March 7, 2025

ADDENDUM #3

TO CONTRACT DOCUMENTS FOR: Project #CP242812 – Jesse Hall Auditorium –
Building Envelope Update

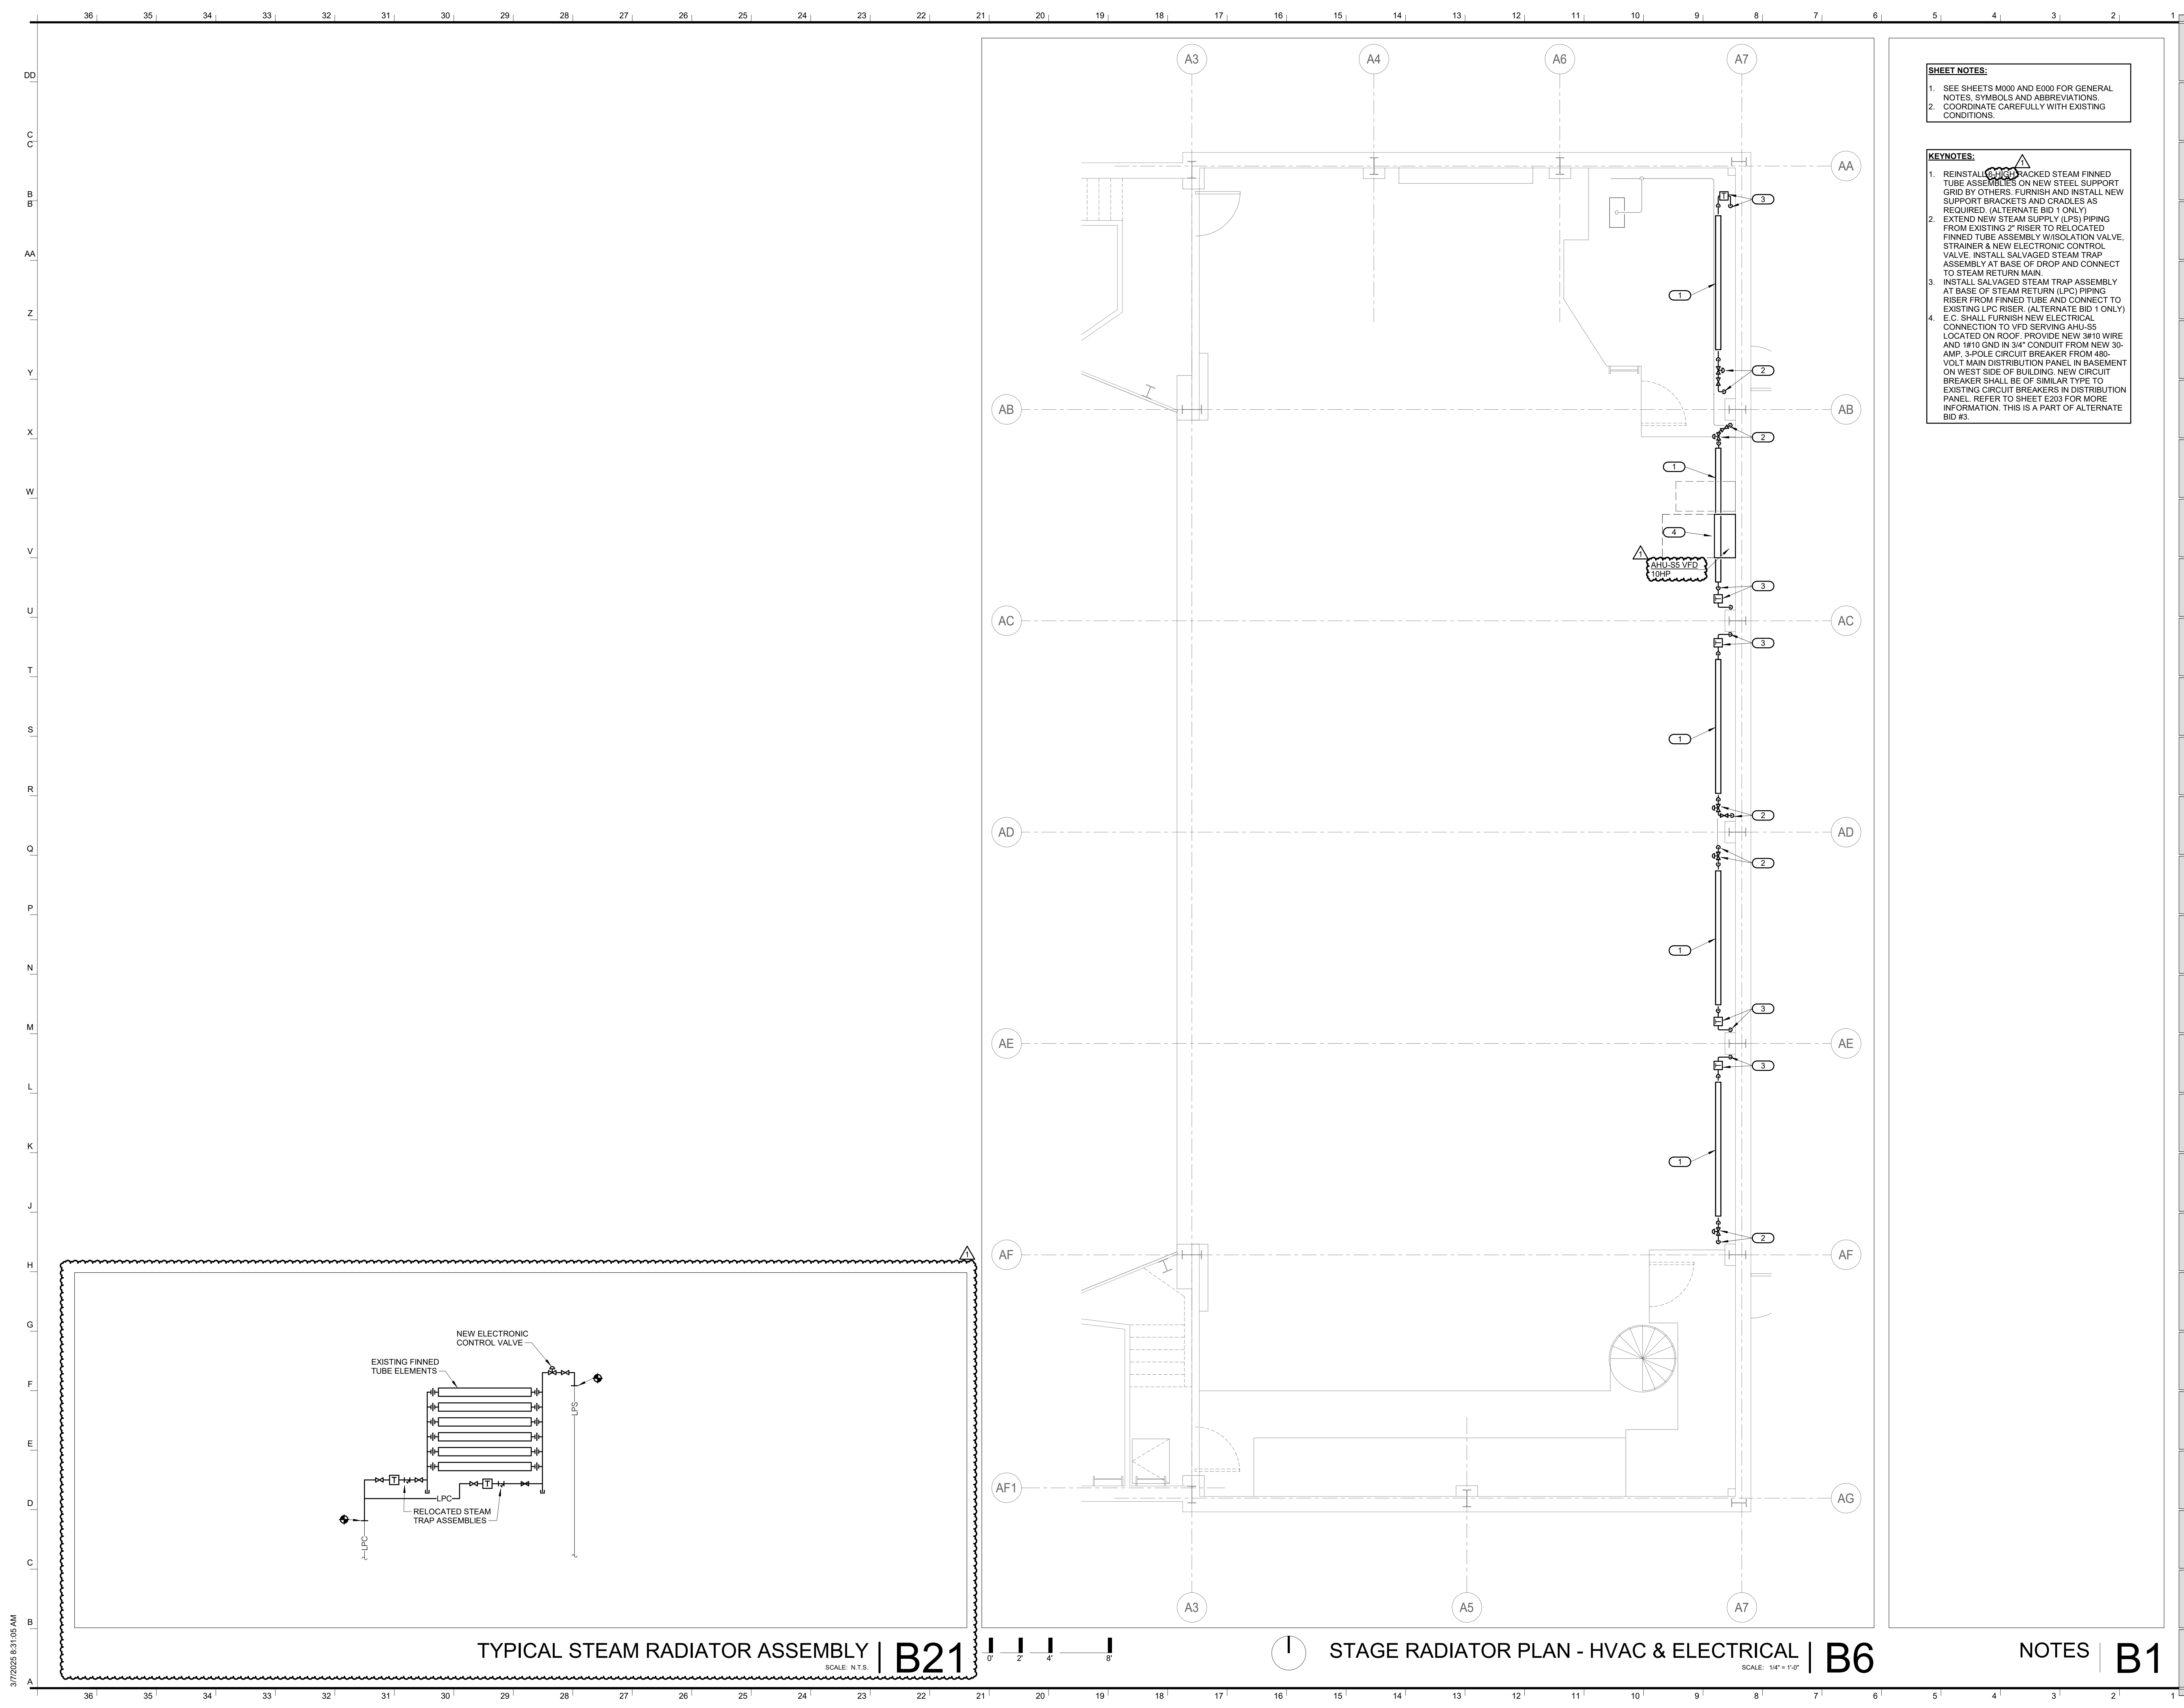
- G. The ground wire should be of the same size as the power conductors from the motor to the VFD and from the VFD to the source.
- H. Do not install VFD's on AHU's. See detail below.

ME202

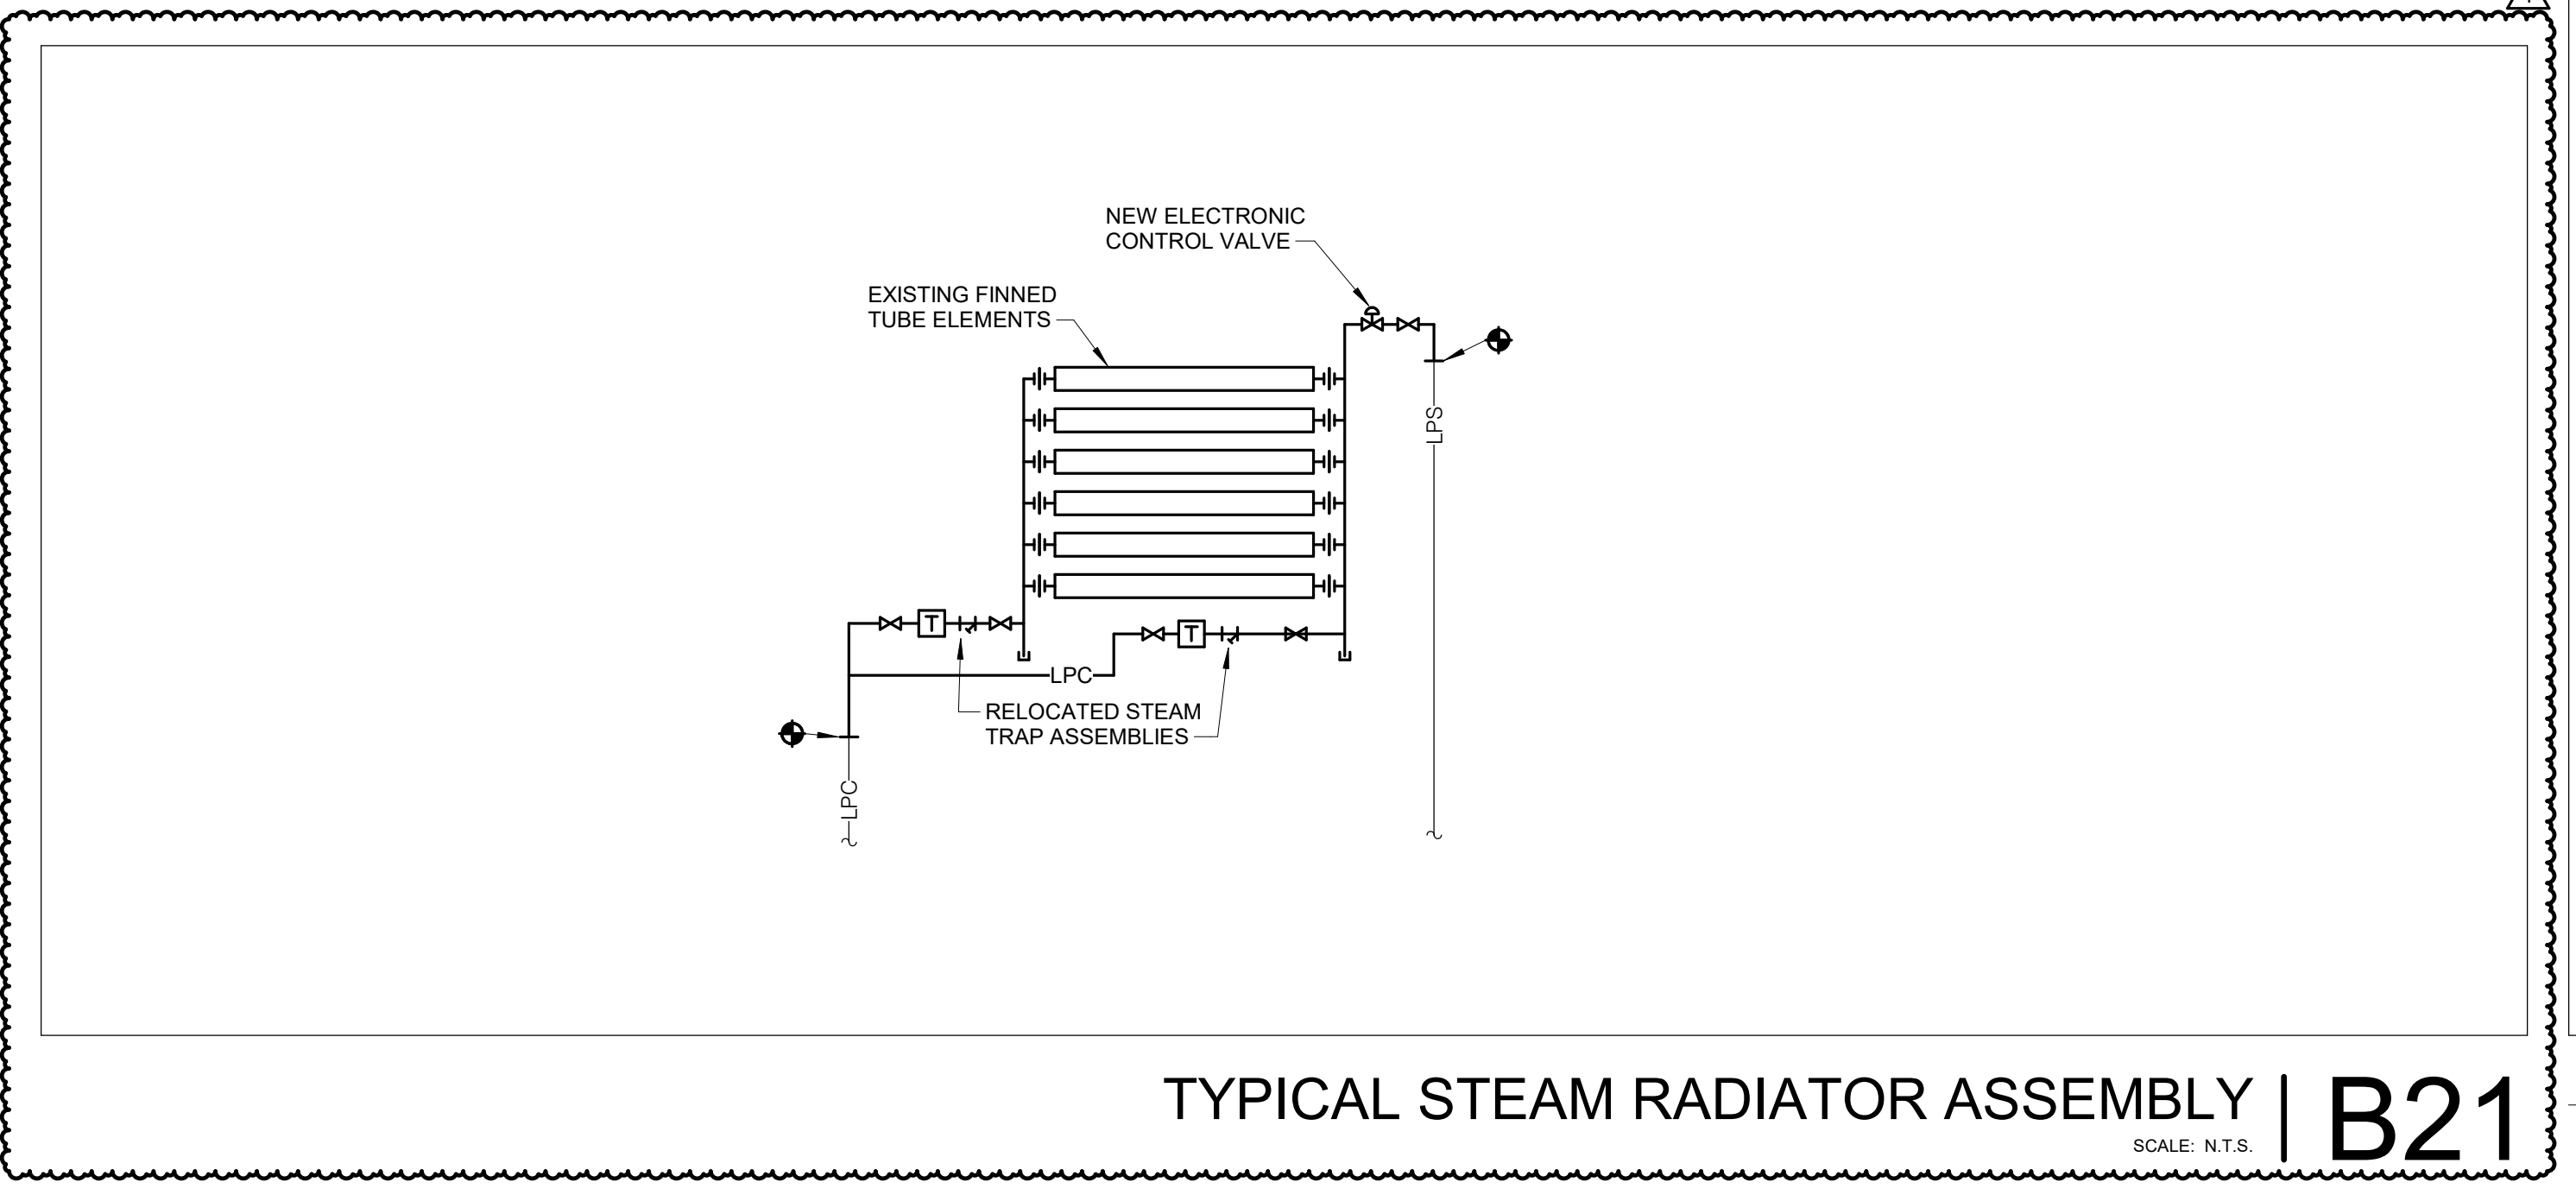
DELETE: “Min. outside air & economizer” in Keynote 7 and
REPLACE WITH: “Outside air”.
- 2) Drawing Sheet: ME202 – STAGE RADIATOR PLAN – HVAC & ELECTRICAL
ADD: “Typical Steam Radiator Assembly” detail B21/ME202 on attached sheet.
REVISE: VFD note on plan B6/ME202 on attached sheet.

- 4) Sheet ME202 note 4 – Indicates a new electrical feed to a vfd serving the RTU. Is this vfd existing? I don't see it scheduled anywhere, nor do I see a specification section for it. Although there is a vfd mounting detail on sheet M500.

RESPONSE: See attached specification section 262923 and revised sheet ME202 for requirements for the vfd unit.

- E.C. SHALL FURNISH NEW ELECTRICAL CONNECTION TO VFD SERVING AHU-SS LOCATED ON ROOF. PROVIDE NEW #10 WIRE AND #10 GND IN 3/4" CONDUIT FROM NEW 30-AMP, 3-POLE CIRCUIT BREAKER FROM 480VOLT MAIN DISTRIBUTION PANEL IN BASEMENT ON WEST SIDE OF BUILDING. NEW CIRCUIT BREAKER SHALL BE OF SIMILAR TYPE TO EXISTING CIRCUIT BREAKERS IN DISTRIBUTION PANEL. REFER TO SHEET E203 FOR MORE INFORMATION. THIS IS A PART OF ALTERNATE BID #3.
